SUBJECT: THREE MILE ISLAND NUCLEAR STATION, UNIT 1
OPERATING LICENSE NO. DPR-50
DOCKET NO. 50-289
LICENSE CHANGE APPLICATION (LCA) NO. 286

Three Mile Island Nuclear Station, Unit 1
Operating License No. DPR-50
Docket No. 50-289
License Change Application (LCA) No. 286

TMI Unit 1 License Change Application No. 286
Safety Evaluation and No Significant Hazards Consideration Analysis

Figure 1

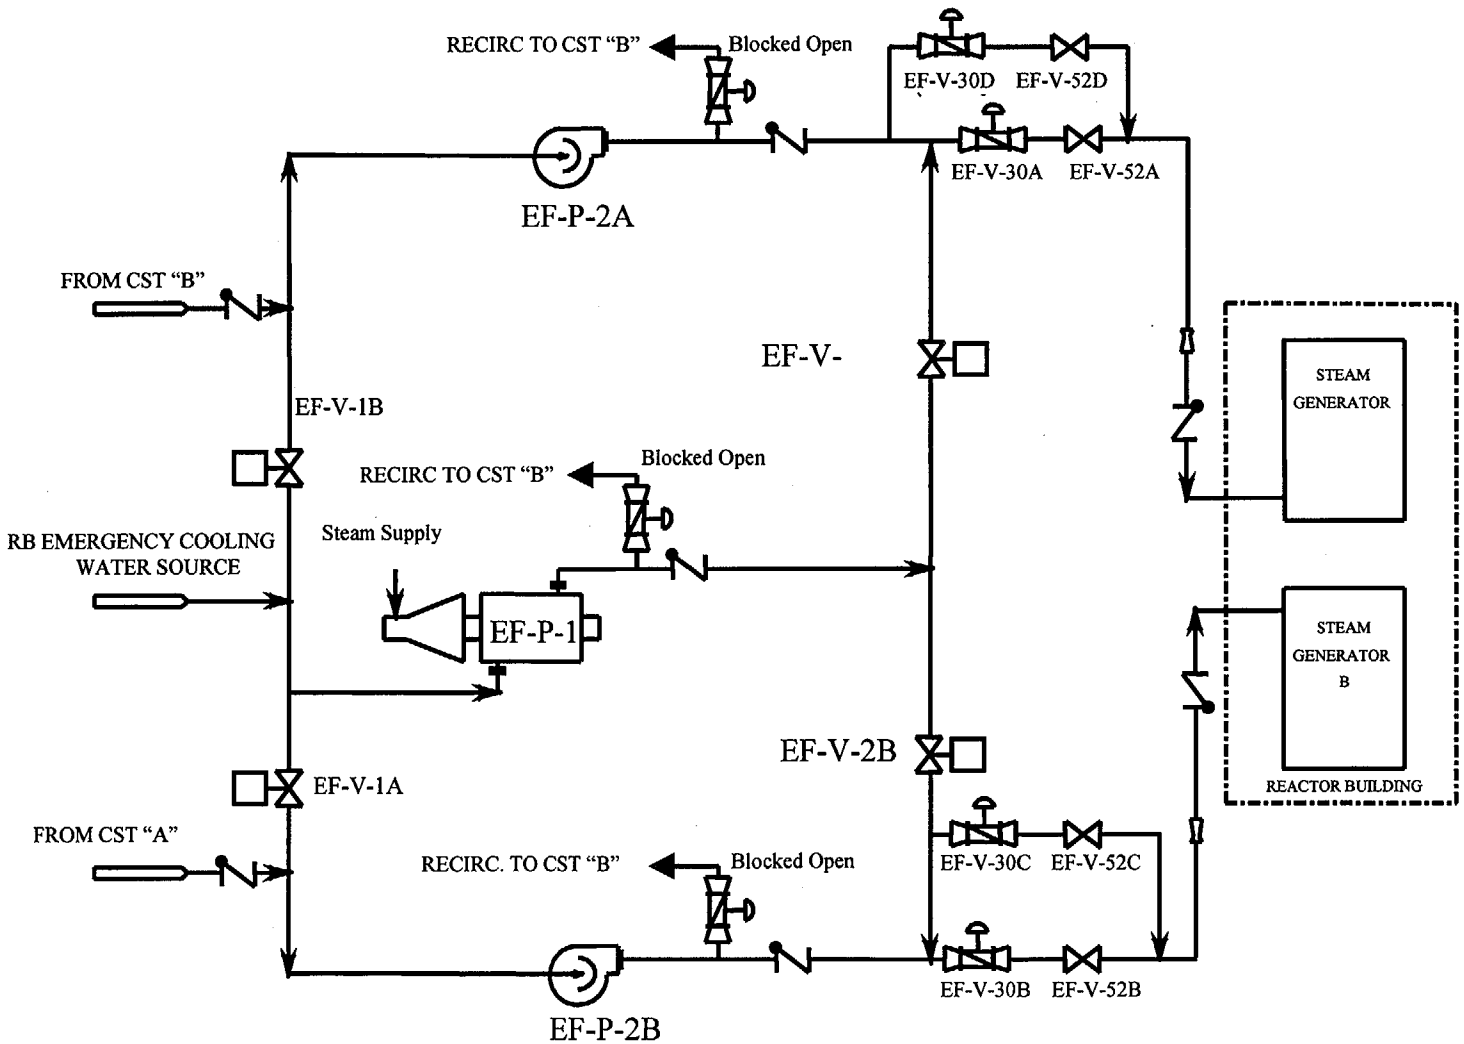
Amendment No. 124 incorporated the EFW long term upgrades required by NUREG-0737, Item II.E.1, including the safety grade Heat Sink Protection System (HSPS) for automatic initiation of EFW and OTSG water level control. One of the EFW long-term upgrades added a redundant EFW flowpath in the line to each OTSG. As such, each OTSG has two redundant flowpaths. Each redundant flowpath to an OTSG includes an automatic control valve and a

manual isolation valve. OTSG "A" has two flowpaths using EF-V-30A and EF-V-52A (Path A) or EF-V-30D and EF-V-52D (Path D). OTSG "B" has two flowpaths using EF-V-30B and EF-V-52B (Path B) or EF-V-30C and EF-V-52C (Path C). To accommodate the revised definition of an EFW flowpath and apply the concept of flowpath redundancy to the EFW LCOs, conforming changes are needed to the EFW System requirements throughout the TS for consistency and clarity.
